JOSEPH M. FARLEY NUCLEAR PLANT, UNIT 1

AMENDMENT TO FACILITY OPERATING LICENSE

Amendment No. 146
License No. NPF-2

ATTACHMENT TO LICENSE AMENDMENT NO. 146

Figure 3.4.16-1

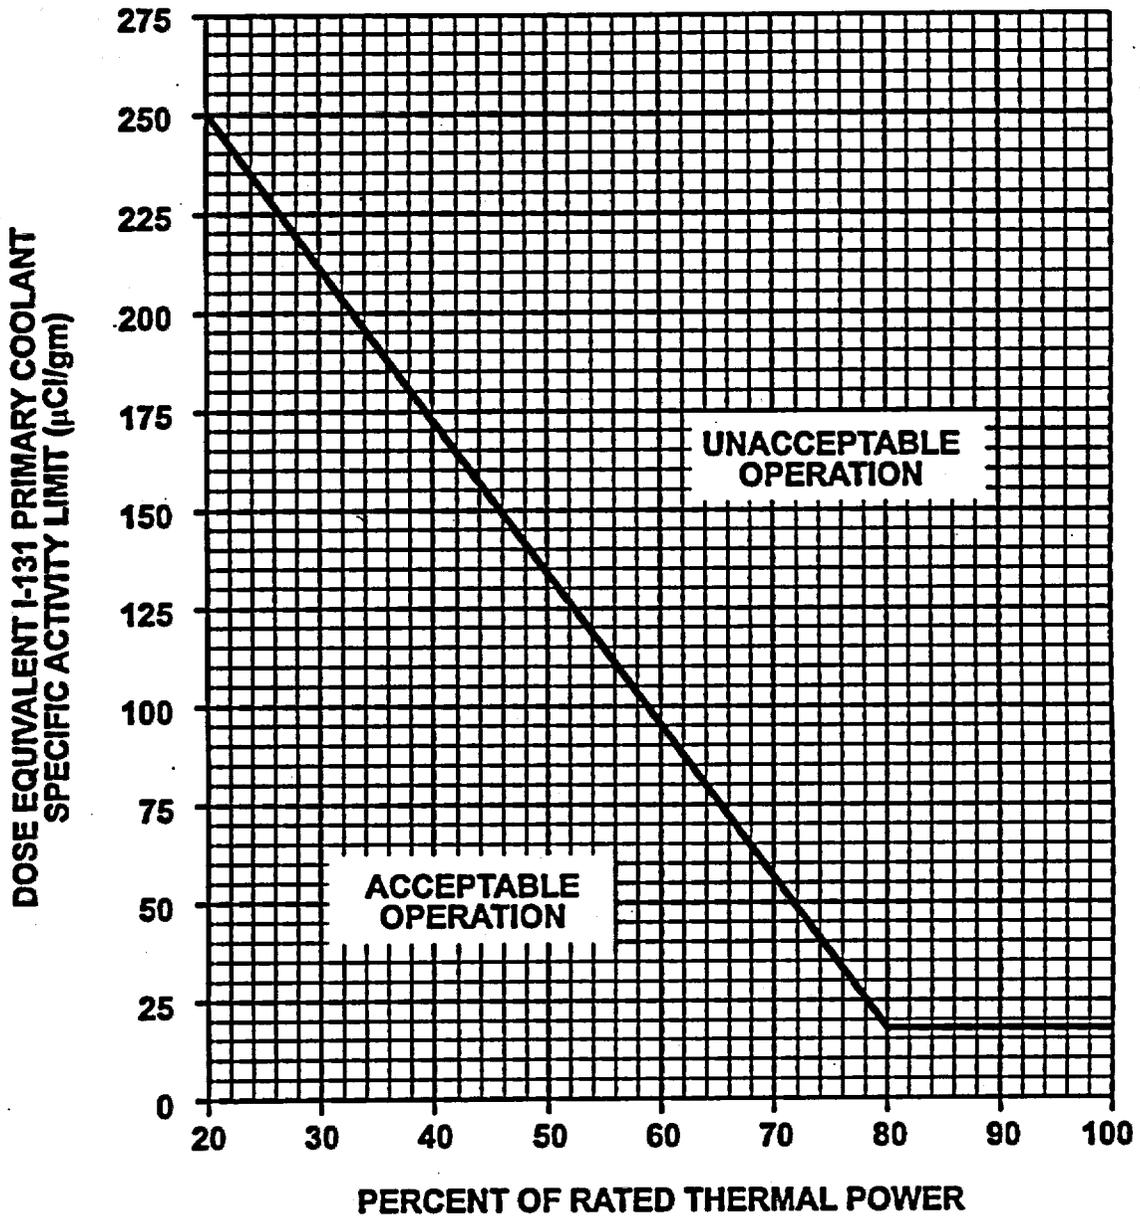
Discussion Of Change (DOC No.)	CTS Reference	ITS Reference	Summary of Change
14-A	3/4.4.9	3.4.16	CTS Figure 3.4-1 is retained in ITS and renumbered as Figure 3.4.16-1
			ITS 3.5.5 ECCS SEAL INJECTION FLOW
1-A	3/4.4.7.2	3.5.5	Requirements are moved to ITS LCO 3.5.5; changes are addressed there.
10-A	3/4.4.7.2	3.5.5	Requirements are moved to ITS LCO 3.5.5; changes are addressed there.
			ITS 5.5 PROGRAMS AND MANUALS
1-A	3/4.4.6	5.5	CTS 3/4.4.4.6 STEAM GENERATORS LCO 3.4.6 is effectively replaced by ITS SR 3.4.13.2, which requires verification of steam generator tube integrity in accordance with the Steam Generator Tube Surveillance Program of ITS section 5.5.
3-A	3/4.4.6	5.5	CTS 3/4.4.4.6 STEAM GENERATORS surveillance requirements are moved intact to the Steam Generator Tube Surveillance Program in the Administrative Controls section of ITS, to specification 5.5.9.
2-A	3/4.4.11	5.5	CTS 3/4.4.4.11 RCS STRUCTURAL INTEGRITY surveillances 4.4.11.2 on the RCP Flywheel Inspection Program and 4.4.11.3 on the Main Steamline Inspection Program are moved into the Administrative Controls section of ITS, to specifications 5.5.7 and 5.5.16.
